**Comment Response Matrix
for
Nuclear Regulatory Commission (NRC)
Requests for Additional Information (RAIs) on the
Saltstone Disposal Facility Performance Assessment
(SRR-CWDA-2009-00017, Revision 0, dated October 29, 2009)**

Prepared by: Savannah River Remediation (SRR)
Closure & Waste Disposal Authority
Aiken, SC 29808

**Figure PA-2.1: Peak Mean Dose to a MOP, Any Sector- Case E
(modified from Figure 5.6-38 in SDF PA)**

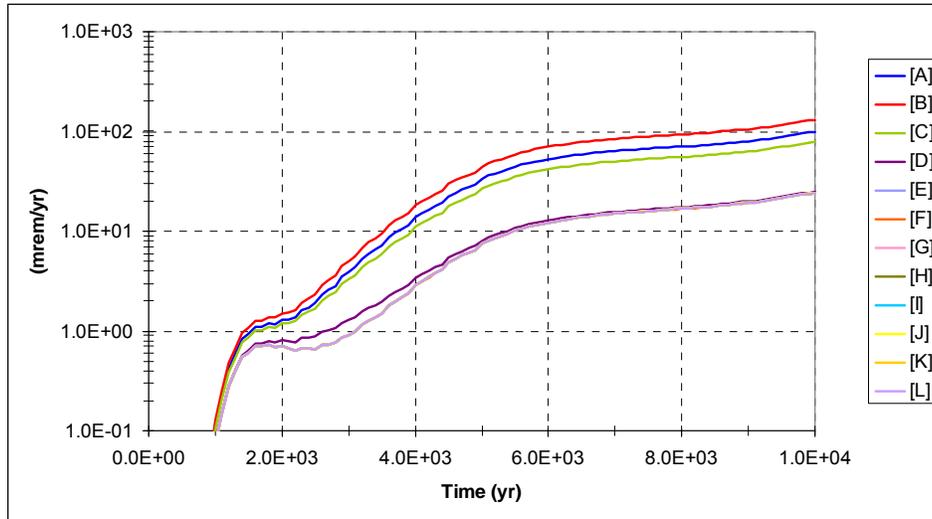
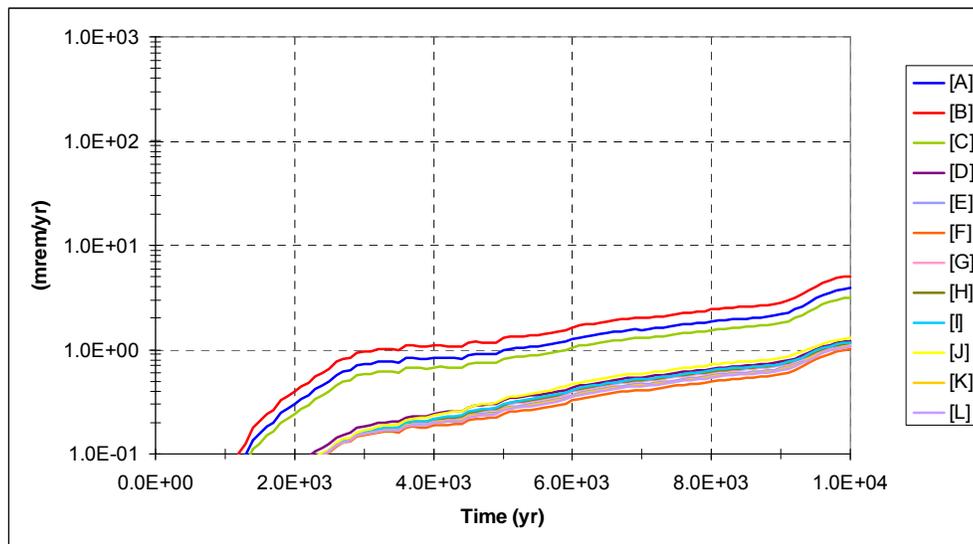
<p><u>PA-2</u></p>	<p>Probabilistic sensitivity analyses were not provided for cases representing bulk saltstone degradation.</p> <p><u>Basis</u></p> <p>Probabilistic sensitivity analyses were performed only for Cases A and C. Although Case C represents a fast flow pathway through saltstone, neither Case A nor Case C represents degradation of the bulk saltstone matrix. Case E, which represents saltstone degradation, was not included in the sensitivity analysis. Dose sensitivities in a case with degraded saltstone are expected to be different from the sensitivities in a case without degraded saltstone. For example, because chemical transitions would be achieved earlier in a case in which bulk saltstone has a greater hydraulic conductivity, parameters affecting the transport of radionuclides sensitive to pH transitions in saltstone may have a greater effect on dose. Similarly, parameters related to slower-moving radionuclides (e.g., plutonium) may have a more significant effect on dose in a case in which more water moves through the bulk saltstone. The sensitivity of these parameters is important to identifying issues that should be tracked during monitoring.</p> <p><u>Path Forward</u></p> <p>Provide a probabilistic sensitivity analysis for a case that reflects saltstone degradation, or explain why the sensitivity analyses performed in the PA are expected to reflect the sensitivities of dose in a case that reflects saltstone degradation. If a new sensitivity analysis is performed, it should be consistent with any modifications made in response to the comments in this document.</p>

<p><u>RESPONSE PA-2:</u></p> <p>This response provides results for the probabilistic uncertainty and sensitivity analysis for the severely degraded saltstone Case E over 10,000 years. Degraded saltstone is assumed to take the form of cracked grout and has been modeled by increasing its hydraulic conductivity to a value of 1.7E-3 cm/sec.</p> <p>As emphasized in SDF PA Section 5.6.4, the results of the uncertainty and sensitivity model are not intended to predict future potential dose for comparison to performance objectives (the SDF PORFLOW model has been used for assessment of peak doses versus performance objectives). Rather, the goal of this SDF modeling is to characterize the context of uncertainty and sensitivity surrounding the PA calculations involving doses to MOP exposed via groundwater. Case E is an extreme case based on the very high hydraulic conductivity value used, which is approximately two orders of magnitude higher than backfill soil. The relative influence of Case E on the composite "AllCases" result is evident by comparing Figure PA-2.1 and Figure PA-2.2 below.</p>

Figure 1: Moisture characteristic curves adapted from the PA and WSRC-STI-2006-00198

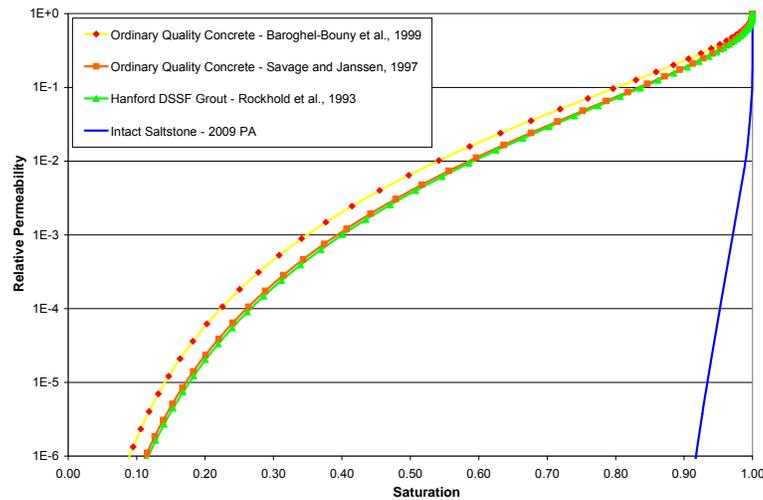
The PA implements curves substantially different from those found in literature. For example, the curves in the PA are significantly different from the curves discussed in "*Hydraulic Property Data Package for the E-Area and Z-Area Soils, Cementitious Materials, and Waste Zones*" (WSRC-STI-2006-00198) (Figure 1). The moisture

Provide additional justification for the moisture characteristic curve for intact saltstone implemented in the PA model by addressing the experimental sources of uncertainty described in the basis. Alternately, provide updated results of Cases A, B, C, D, the synergistic case, and the sensitivity case in Section 5.6.6.7 that use a characteristic curve for intact saltstone that is more consistent with results in the literature. Any updated analysis should be consistent with the response to SP-4.

Figure 2: Characteristic curves for the intact and fractured saltstone and concrete as adapted from the 2009 PA and SRNL-STI-2009-00115

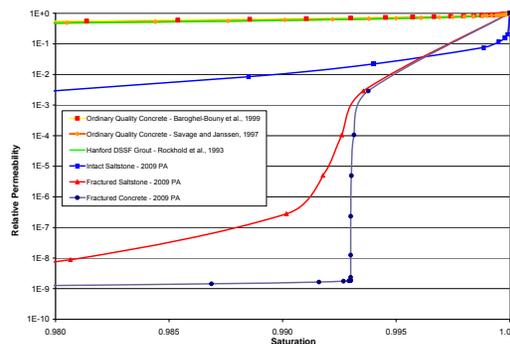
The characteristic curves developed by INL (referred to in SP-3) were also used as the basis for the fractured saltstone and concrete characteristic curves (see Figure 2 below) that were developed in “Numerical Flow and Transport Simulations Supporting the Saltstone Disposal Facility Performance Assessment” (SRNL-STI-2009-00115). The authors discuss the use of an analytical approach developed by Or and Tuller (2000) to adapt INL moisture characteristic curves for cracked cementitious materials because experimental characteristic data for cracked vault concrete and saltstone grout are not available (SRNL-STI-2009-00115). However, use of moisture characteristic curves combined with coarse spatial and temporal averaging can result in an inadequate representation of non-equilibrium flow.

Provide additional support for the modeled flow through fractures. Model support could include field observations and laboratory experiments that verify consistency between numerical results and physical measurements.

Figure SP-6.1: Calculated Peclet Number for SDF PA Case A

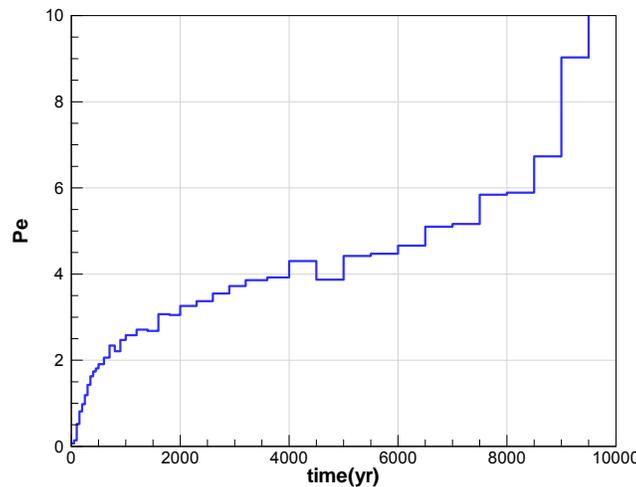
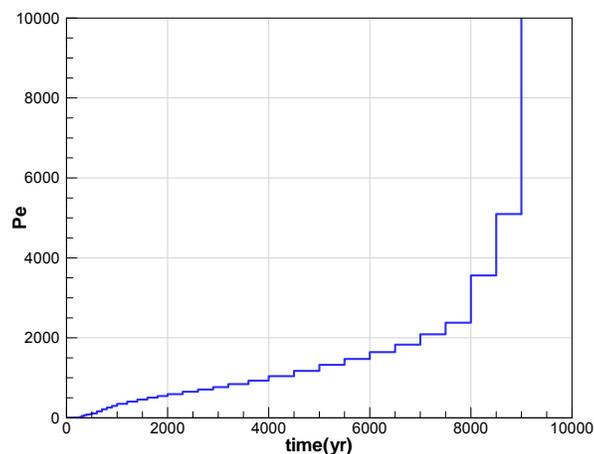
<p><u>SP-6</u></p>	<p>Comment: Additional basis is required for the values of the effective diffusivity of intact and degraded saltstone used in the base case and sensitivity cases.</p> <p><u>Basis</u></p> <p>As discussed in comment SP-1, the effects of degradation of bulk saltstone (as compared to fractures in otherwise intact saltstone) are addressed in sensitivity Case E, in the synergistic case discussed in Section 5.6.6.5, and in an increased saltstone hydraulic conductivity case discussed in Section 5.6.6.7. In each of these cases, the hydraulic conductivity of saltstone is adjusted, but the effective diffusivity is kept constant at the base-case value. Because both the effective diffusion coefficient and hydraulic conductivity are intimately related to pore structure in cementitious materials, it is reasonable to expect that both coefficients would increase as saltstone degrades. The basis for adjusting the hydraulic conductivity in the sensitivity cases but maintaining the effective diffusivity at the base-case value does not appear to be addressed in the PA.</p> <p>In addition, clarification is needed of the basis for the effective diffusivity of intact saltstone. The supporting document "Numerical Flow and Transport Simulations Supporting the Saltstone Disposal Facility Performance Assessment" (SRNL-STI-2009-00115) indicates that the effective diffusivity is based on a comparison to other cementitious materials with similar hydraulic conductivities, but the specific materials used for comparison and the process by which an effective diffusivity value was selected are not provided. Table 4.4-16 of the PA indicates that the effective diffusion coefficient is based on the effective diffusion coefficient of high quality concrete in the supporting document "Hydraulic and Physical Properties of Saltstone Grouts and Vault Concretes" (WSRC-STI-2006-00198). However, the actual value of the effective diffusion coefficient for high quality concretes provided in Tables 6-44 and 6-47 of WSRC-STI-2006-00198 is 5 E-8 cm²/s, which does not match the value of 1.0 E-7 cm²/s used in the PA for saltstone. Furthermore, it is not clear why an effective diffusivity value appropriate for high quality concrete, which has a porosity of 0.11 (PA Table 4.2-16) would be appropriate for saltstone, which has a porosity of 0.58 (PA Table 4.2-16). While the choice of an effective diffusion coefficient of 1.0 E-7 cm²/s is more pessimistic than the value provided for high quality concrete in the supporting document, the basis for the effective diffusivity value chosen should be clarified.</p> <p><u>Path Forward</u></p> <p>Provide a basis for using the effective diffusivity of intact saltstone in the two sensitivity cases that address degraded saltstone listed in the basis or update the sensitivity cases that address degraded saltstone with a value of effective diffusivity that reflects the physical degradation of the wasteform. Clarify the basis for the value of the effective diffusivity of intact saltstone.</p>

<p><u>RESPONSE SP-6:</u></p> <p>While the diffusion coefficient would be expected to increase as the saltstone degrades, the transport is advection dominated except during the first few hundred years after closure as indicated by the Peclet number for Case A for Vault 4 as presented in Figure SP-6.1. As indicated in Figure 5.5-1 in the SDF PA, the peak dose in 10,000 years is in Sector B at year</p>

10,000 and is dominated by releases from Vault 4. At year 10,000 the Peclet number is greater than 10 indicating the dominance of advective versus diffusive transport. Therefore, any change in the diffusion coefficient will not have a noticeable impact on the calculated peak dose results.

Similarly, for Case E (the configuration case with significantly degraded saltstone properties) Figure SP-6.2 presents the Peclet number for Vault 4 within 10,000 years. As indicated in Figure 5.6-72 in the SDF PA, the peak dose in 10,000 years is in Sector B at approximately year 9,400 and the Peclet number is greater than 10,000 indicating the dominance of advective versus diffusive transport. As in Case A, any change in the diffusion coefficient will not have a noticeable impact on the calculated peak dose results.
